RE: RESPONSE TO INFORMATION REQUEST AND NOTICE OF INTENTION TO COMMENCE PUBLIC NOTIFICATION IN RELATION TO THE DEVELOPMENT APPLICATION FOR A DEVELOPMENT PERMIT FOR A MATERIAL CHANGE OF USE (WAREHOUSE – SELF STORAGE) OVER LAND AT 29 FRONT STREET, MOSSMAN, MORE FORMALLY DESCRIBED AS LOT 34 ON RP706256

COUNCIL REF: MCUI 2026_6011/1

Revised Proposal Plan Set

SITE PLAN
1 : 200

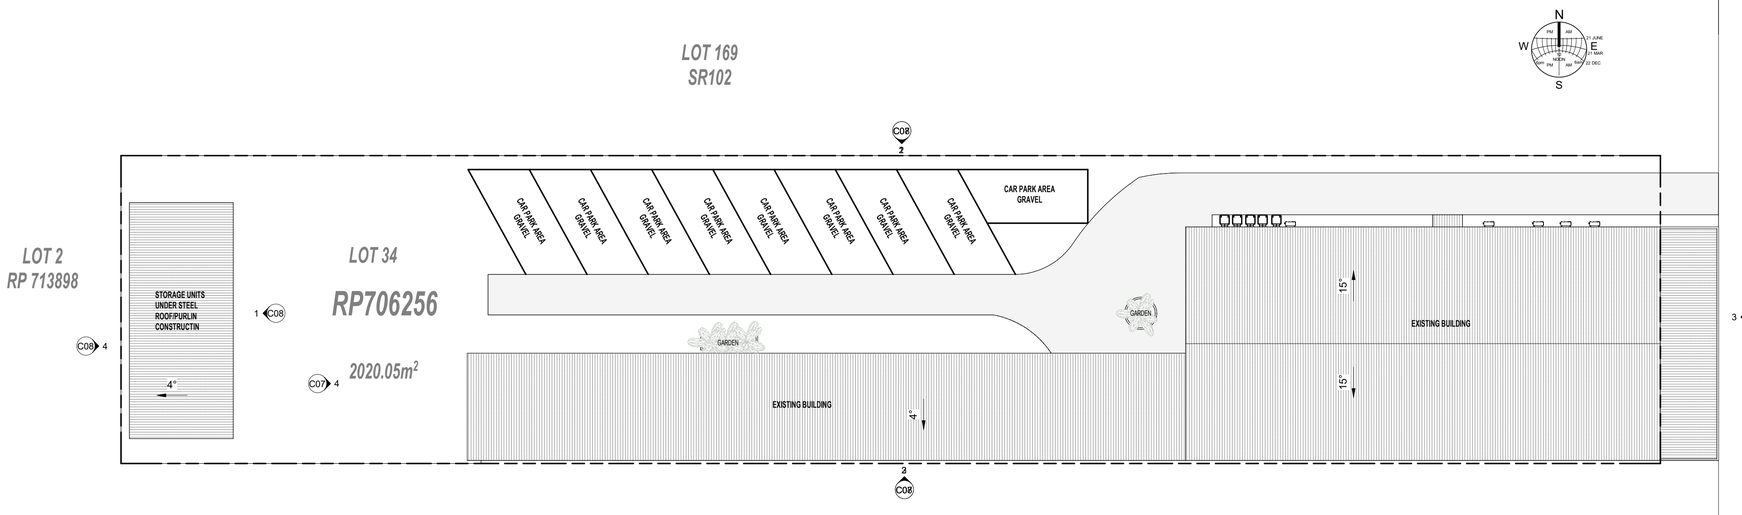
Please provide the gross Floor Area for all existing buildings on the premises.

The Revised Proposal Plan Set has been updated to include existing Front and Side Building Areas, refer to **Attachment A**.

- Front Building = 494m^2
- Side Building = 253m^2
- Proposed Storage Containers = 90m^2

AREA KEY - SITE COVERAGE	
SITE AREA	2020.05m²
FRONT BUILDING	494m²
SIDE BUILDING	253m²
TOTAL OF EXISTING BUILDINGS	747m²
EXISTING COVERAGE %	36.98%
NEW STORAGE CONTAINERS	90m²
NEW GFA	837m²
COVERAGE %	41.43%

FLOOR PLAN - LOWER

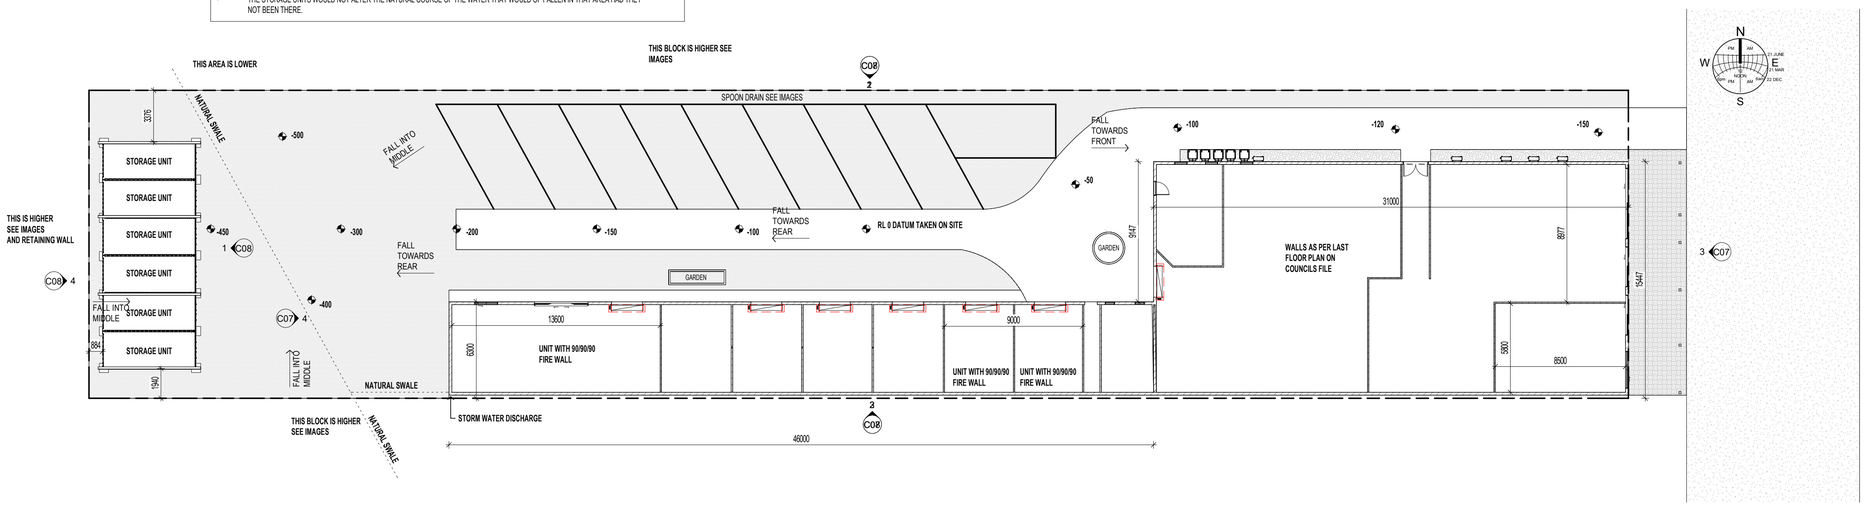
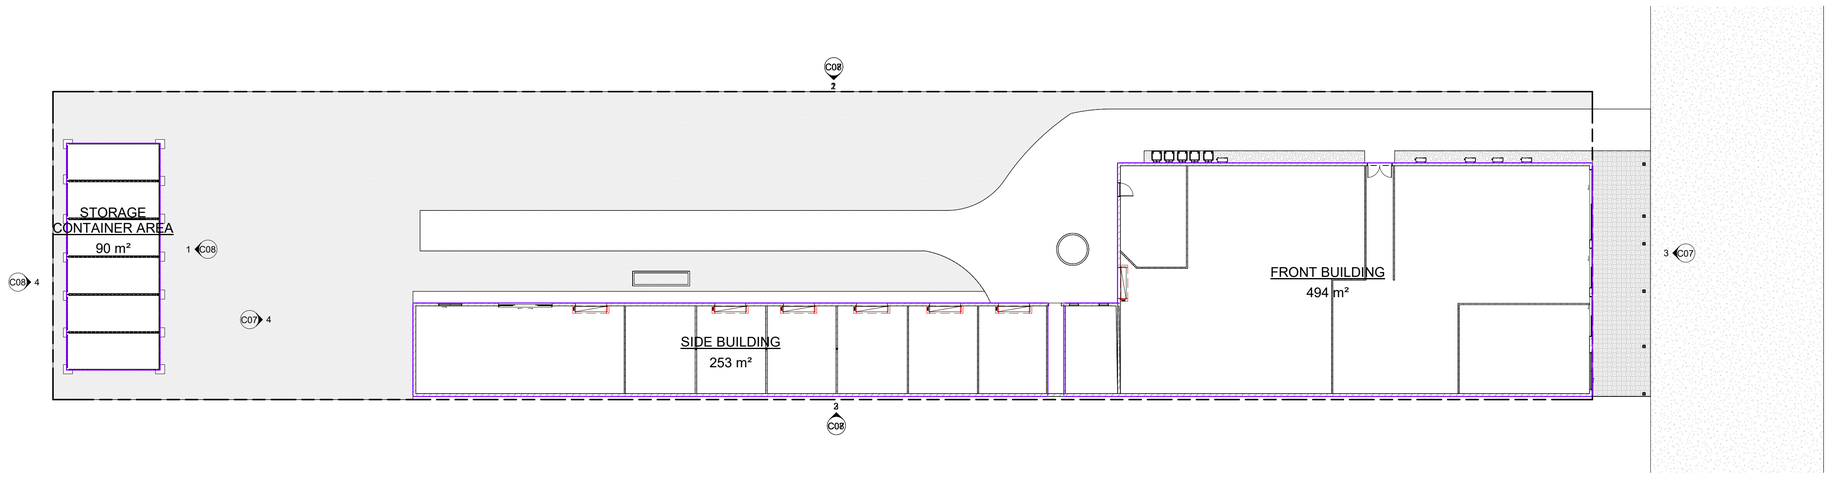
2. Please provide details of any fill that has occurred on the land, provide overland flow for the pre- development and post development civil design, including catchment and dispersal of stormwater and overland flow to ensure the development does not have any worsening effect on upstream, downstream or surrounding land.

NOTES REGARDING FALLS AND STORM WATER RUN OFF

- NO FILL WAS BROUGH INTO SITE FOR THE PLACEMENT OF THE SEE CONTAINER STORAGE UNITS. THEY WERE PLACED ON MASS CONCRETE FOOTINGS AND CHAINED INTO POSSITION APPROX 300mm FROM GROUND NATURAL HEIGHT.

- THE AREA IS AT THE LOWEST PART OF THE BLOCK MAKING IT DIFFICULT TO DISCHARGE TO THE FRONT STREET FOR STORM WATER AS THIS IS LOCATED AT A HIGHER RELATIVE LEVEL.

- NEIGHBOURING SITES SIT HIGHER IN ELEVATION AND HAVE A NATURAL SWALE IN THE GROUND AN STORM WATER RUNS FROM THOSE SITES INTO THIS AREA ACROSS AND INTO THE NEIGHBOURING SITE, HOWEVER DUE TO THE SITE AND NATURAL GROUND THIS WOULD NOT BE ABLE TO BE RECTIFIED OR WOULD FURTHER IMPACT OTHER SITES, THIS GROUND HAS BEEN LEFT UNDISTURBED FOR SOME TIME NOW.

- THE OWNERS HAVE MENTIONED THAT THE SITE HAS BEEN THROUGH NORMAL RAIN EVENTS FINE WITH NO FLOODING
- THE STORAGE UNITS WOULD NOT ALTER THE NATURAL COURSE OF THE WATER THAT WOULD OF FALLEN IN THAT AREA HAD THEY NOT BEEN THERE.
